## *City of Jeffersonville's Responses to the List of Technical Questions Regarding Jeffersonville LTCP Amendment Proposal.*

The following list of questions is being submitted to Jeffersonville by U.S. EPA and IDEM regarding the proposal outlined in Jeffersonville's October 20, 2017 letter and October 24, 2017 supplement. These questions relate solely to the technical/engineering aspects of Jeffersonville's outlined LTCP amendment proposal. These questions are meant to continue the information exchange but are not intended to constitute an exhaustive list of questions or concerns that U.S. EPA and IDEM may have regarding Jeffersonville's submittals to date. These questions do not reflect U.S. EPA's and IDEM's concerns regarding Jeffersonville's financial justification for an LTCP modification; nor do these questions presuppose that a financial case for LTCP modification has been adequately demonstrated.

10th Street Pump Station  
Summary Sheet 08/03/2011

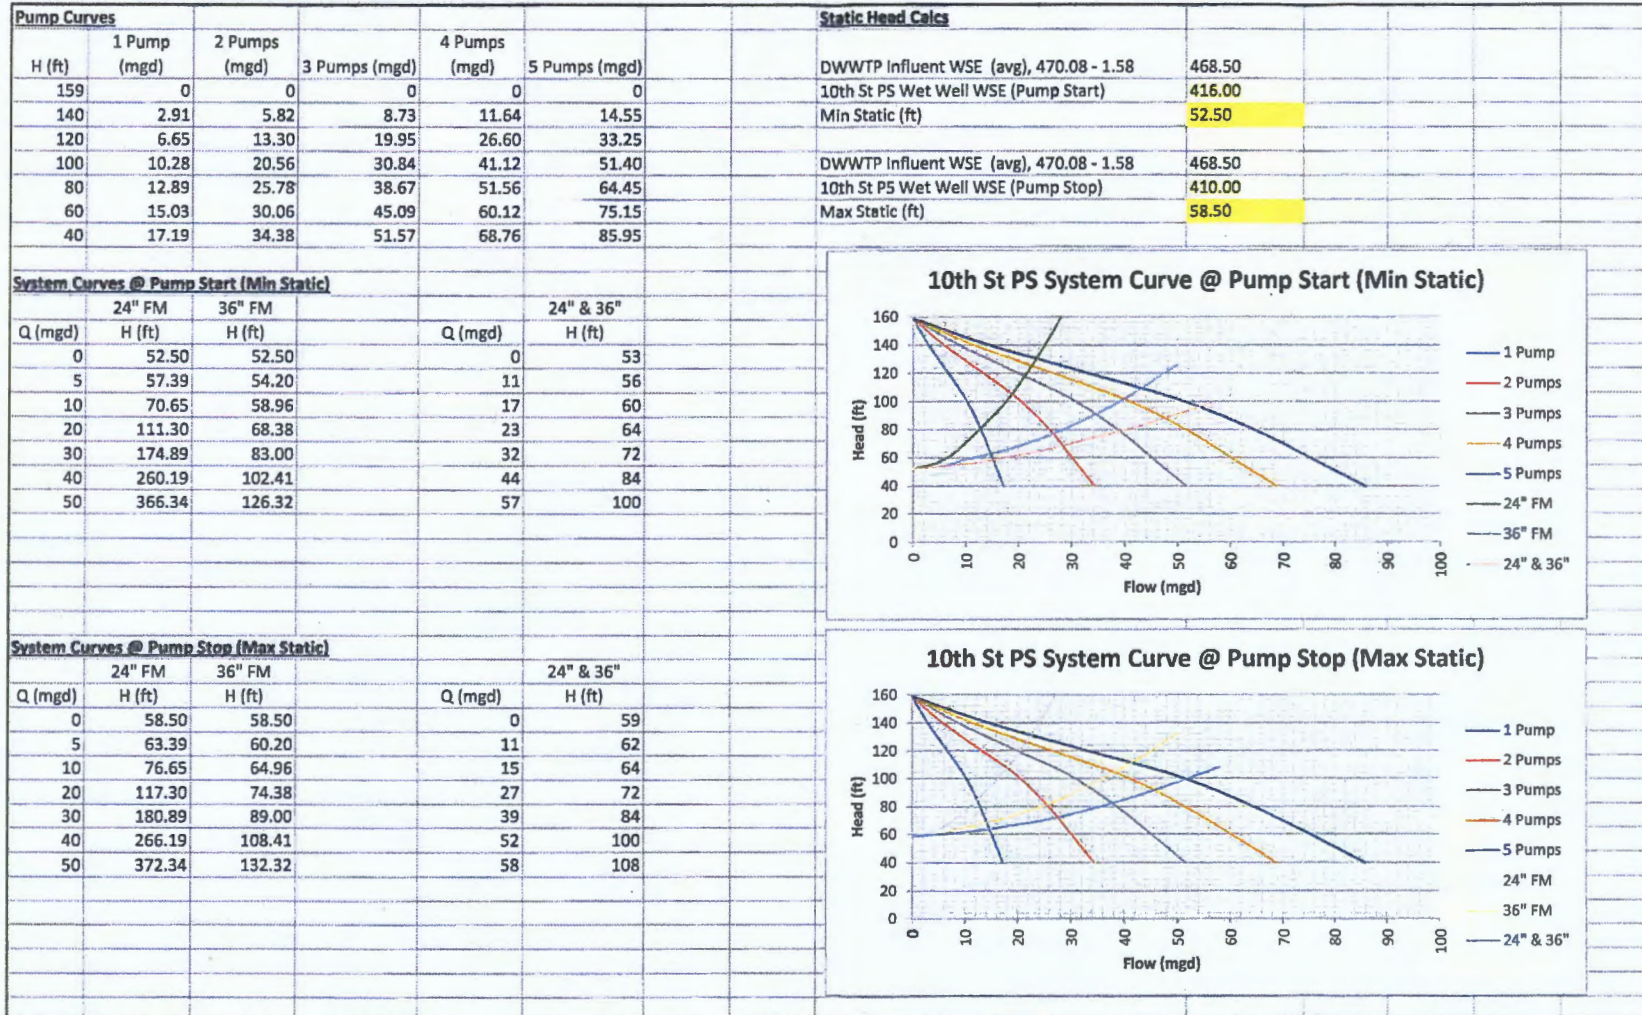
16. Please confirm the peak pumping capacity of the 10<sup>th</sup> Street Lift Station. It is said to be 50 MGD, but that is the maximum flow to the POTW. What about the pumping capacity for the HRT? The Mill Creek pump station peak rate is 8 MGD, the Spring Street pump station peak rate is 6 MGD. How does this affect the proposed 10<sup>th</sup> Street pump station pumping capacity of 50 MGD? Is 50 MGD the capacity with all five pumps running?

*The Tenth Street Lift Station was designed to pump a peak flow of 36,000 gpm (51.84MGD) with all 5 pumps running and both the 24" and the 36" force mains in operation. Attachment E contain the specifications for the pumps and Attachment F contains the approved submittal for the pumps at the lift station.*

## Downtown WWTP – Current Situation – Upto 50.0 MGD Flow

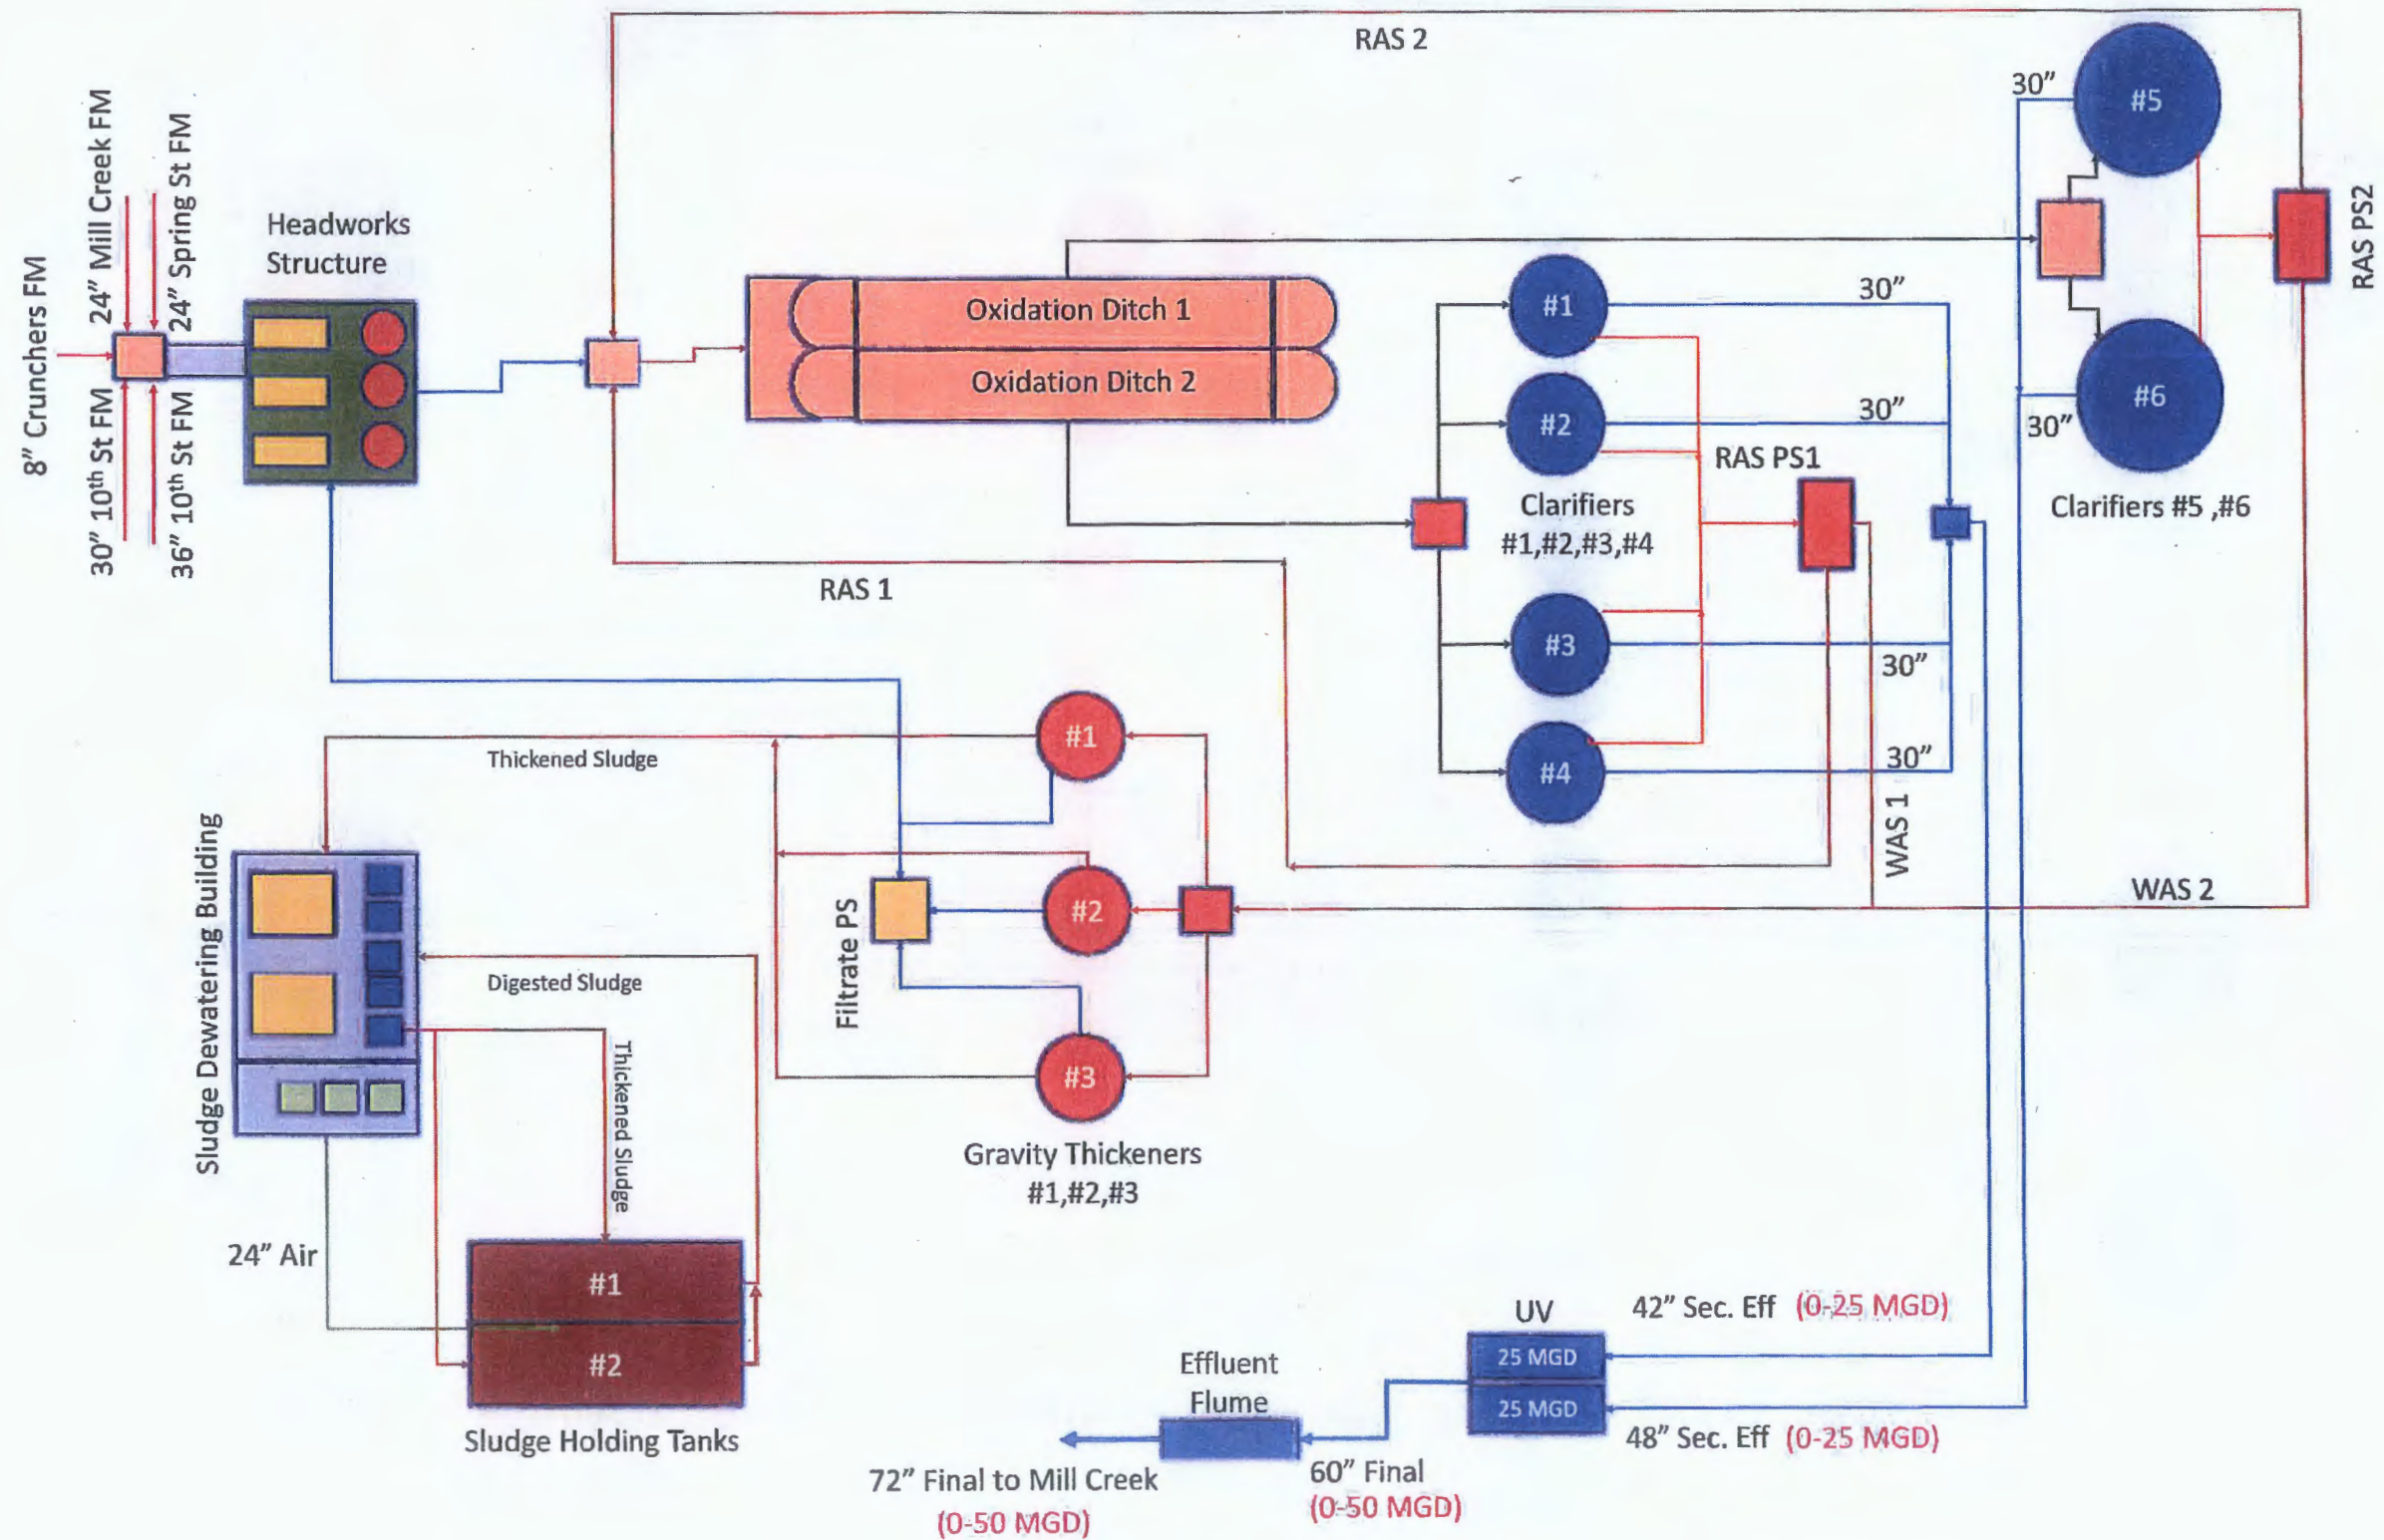
2. Please provide a current flow diagram of the downtown WWTP (including the headworks), and please provide a flow diagram showing the proposed sewer layouts for the 10<sup>th</sup> Street PS and downtown WWTP (including the CEHRT), including the proposed point of sampling for the recombined effluent.

*Process Schematic showing the current treatment processes;*
